### BRENT SPENCE BRIDGE CORRIDOR PROJECT

### **DESIGN SUMMARY REPORT**

AUGUST 23, 2022

Appendix F: Concept I-W Conceptual Signing Plan

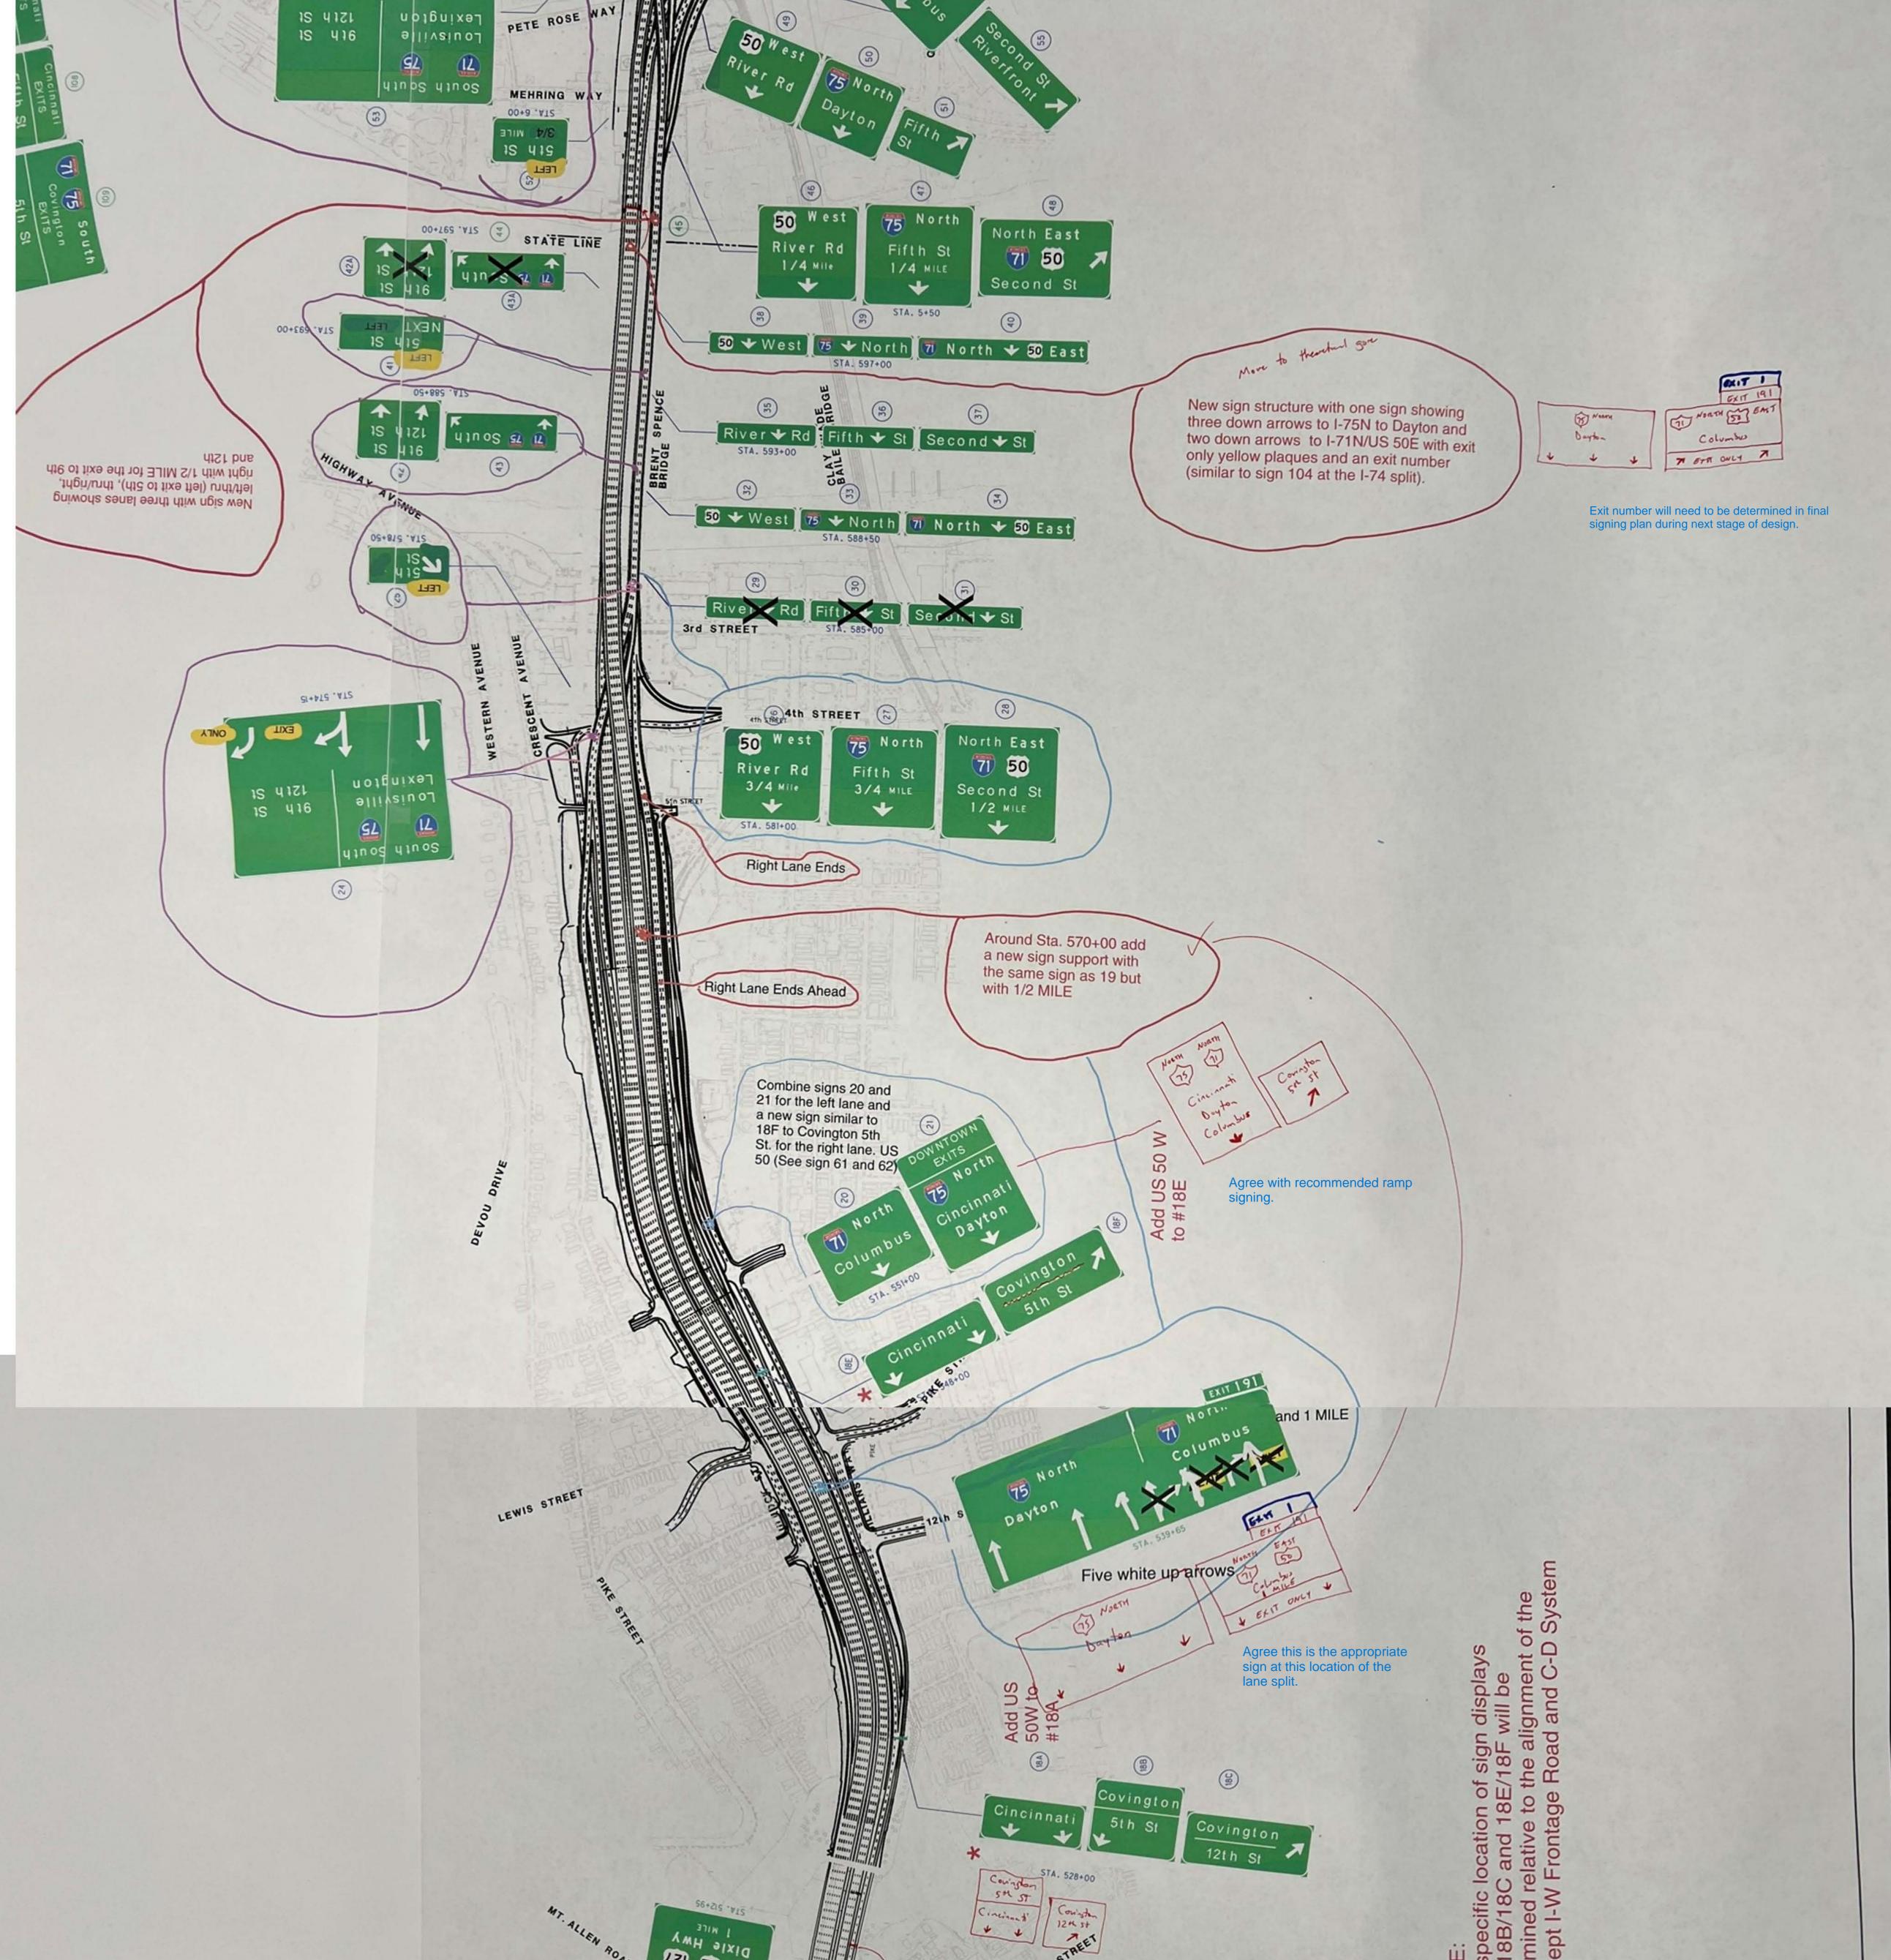
HNTB Review 5/25/2022		5/6/2022 GROKE
A draft signing plan is included with this review as a general idea for sign configuration with all Cincinnati downtown and Riverfront, and Covington traffic in the right three lanes at Ezzard Charles, and the left of those lanes dividing into	I EXIT ONLY 7 PENT ONLY 71	
Seventh and Fifth south of Ezzard Charles. See attachment.	THEY LANGS 71 SOUTH TO LONSVILLE LONSVILLE LONGTON J	llymin
	EXITED EXITION EVENTILIST FIFTLIST THINGST CONNECTING I/Z MILE VIENTONEY VENTONEY VENTONEY	Yumi.
	THEV LANG 71 SUTH 21 JS Lougnice UXINCION	1/4 mi.
	EXIT 13 Servite St FIELS St Think St Shore St 17th 1 MILE WILLE	1/4 mr
Image: Second State       State	THIZ WAVES 71 SOUTH COUISVILLE LEXINGTON J J J	1/4 mi

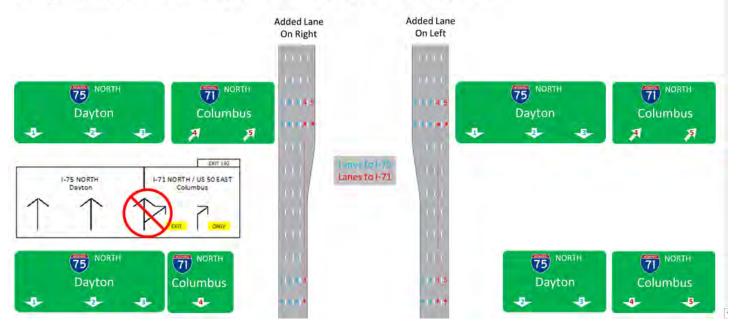
To answer the main question: No, I don't think there are any fatal flaws in Concept I-W. Obviously as we move past conceptual and into more concrete signing plans, there will be some kinks we need to iron out, but all-in-all I think it can be done.

However, regarding the NB lane situation, I maintain that the use of upward facing Arrow-per-Lane signage with an option arrow is not applicable in the area just north of Kyle's Ln. Ignoring the two right lanes that drop at Exit 190, we have 4 "through" lanes at this point. Those 4 lanes become 5 lanes, but its by adding a lane on the far right. So the 3<sup>rd</sup> lane from the left doesn't change at all – if you stay in that lane, you WILL go through to 1-75. It is not an option lane. You have to be in the 4<sup>rh</sup> lane from the left to access 1-71. By being in the 4<sup>rh</sup> lane you can then also get in the 5<sup>rh</sup> lane once it opens up, and either of those two lanes will take you to 1-71 – but not the 3<sup>rd</sup> lane.

If there is concern about directing all of the I-71 traffic into a single lane (before the 5<sup>th</sup> lane gets added), you could change the striping so that the added lane comes in on the left. That would make it to where when you have 4 lanes, it would be 2 lanes for each movement, then the 5<sup>th</sup> lane (added on the left) would make 3 lanes for I-75.

Here is a graphic I put together of both scenarios, depicting the lanes and associated signing to show how Lane 3 never goes to I-71.

The KYTC comments point out that the creation of the fifth lane northbound in Kentucky could be an add-lane on either side of the highway. This will require further design to determine the best fit. There may also be a need for verification of lane use/signing with traffic analysis and modeling to determine how best to position the NB I-75 and I-71 traffic in the four lane section (as a 3 and 1 or 2 and 2 configuration) and how far in advance of the add-lane that the mainline movements should be signed separately. These issues can be addressed as part of the next phase of design.
